Draft revision of Regulation No. 59 (Replacement silencing systems)

A. PROPOSAL

Note: For replacement silencing systems intended to be fitted on vehicles approved with the new measurement method of Regulation No. 51.

Approval mark (para. 5.4. and Annex 2)

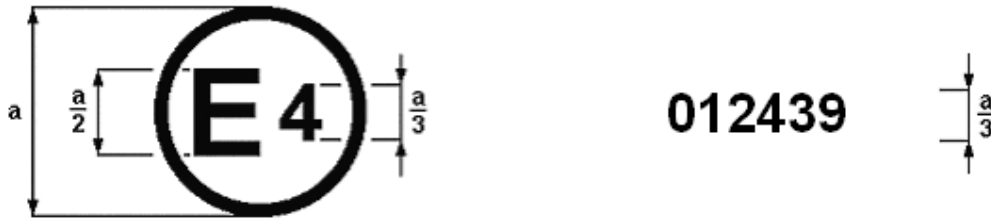
Requirements in line with those of ECE Regulations on components = letter "R" and number of the Regulation are no longer required.

The above approval mark when affixed to a replacement silencing system shows that the type of replacement silencing system concerned, has been approved in the Netherlands (E4) under the approval number 2439. The first two digits of the approval number indicate that the approval was granted according to the requirements of this Regulation as amended by the 01 series of amendments.

Performance criteria for stationary noise (para. 6.2.2.2.)

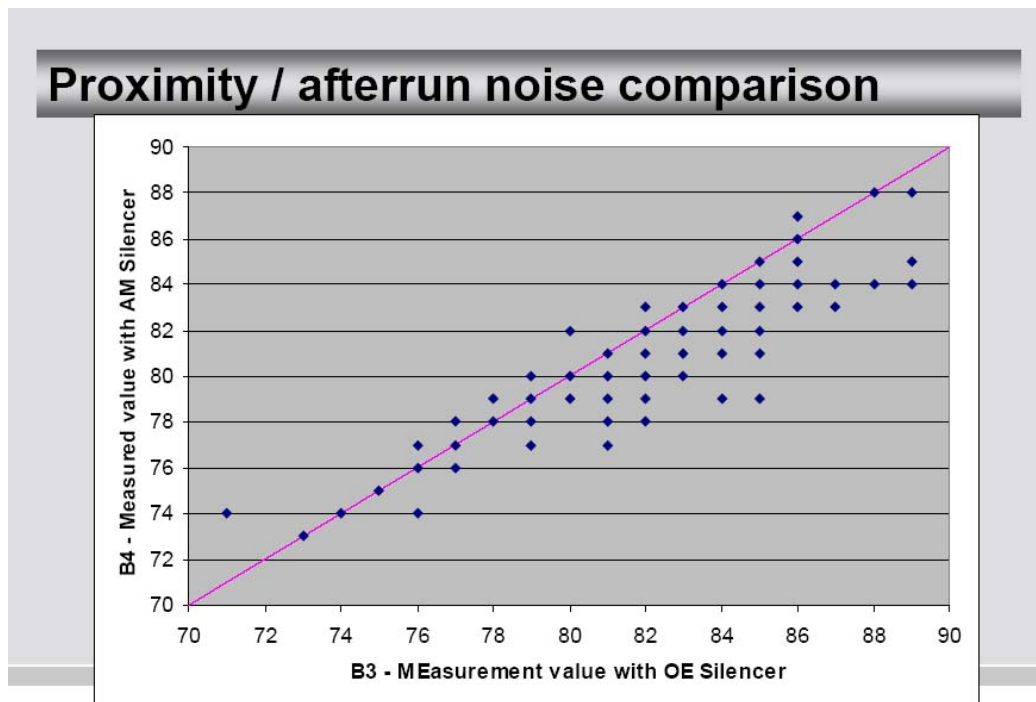
A 3 dB(A) maximum tolerance is proposed, due to the large deviations in measuring this type of noise emissions (see the graph below).

- 6.2.2.2. The noise level measured with the stationary vehicle shall not exceed by more than 3dB(A)
 - 6.2.2.2.1. either the noise level of the stationary vehicle concerned when granted type approval
